Access Compliance Report Public Rights-of-Way (RR Crossings)

Intersection ID: 7375	Main Street: N_TRYON_ST	Location: N/A
ADA ID: 6384FAF7F6D8	Overall Compliance: No	Severity Score: 0.0
Codes/Mitigation Info/Possible Solution		Field Measurements/Component Compliance

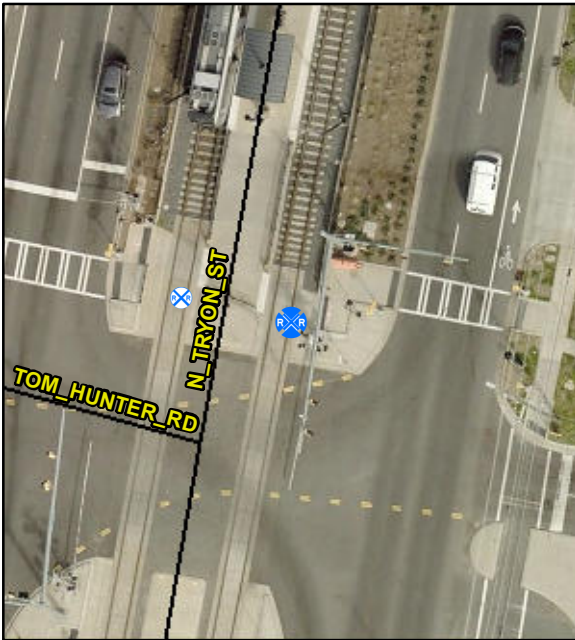
**Remove & Replace Detectable
Warning System. Provide Pedestrian
Gate. Remove & Replace Walking
Surface Adjacent to Rail.**

Compliance	Description	Data
Yes	DWS Provided?	Yes
Yes	DWS Contrast?	Yes
Yes	DWS Width (in)	Yes
Yes	DWS Length (in)	24.0
Yes	DWS Offset (in)	83.0
No	Pedestrian Gate?	No
N/A	DWS Outside Gate?	No
N/A	Rail Type?	LightRail
No	Flangeway Gap (in)	2.75
Yes	Sidewalk Width (in)	108.0
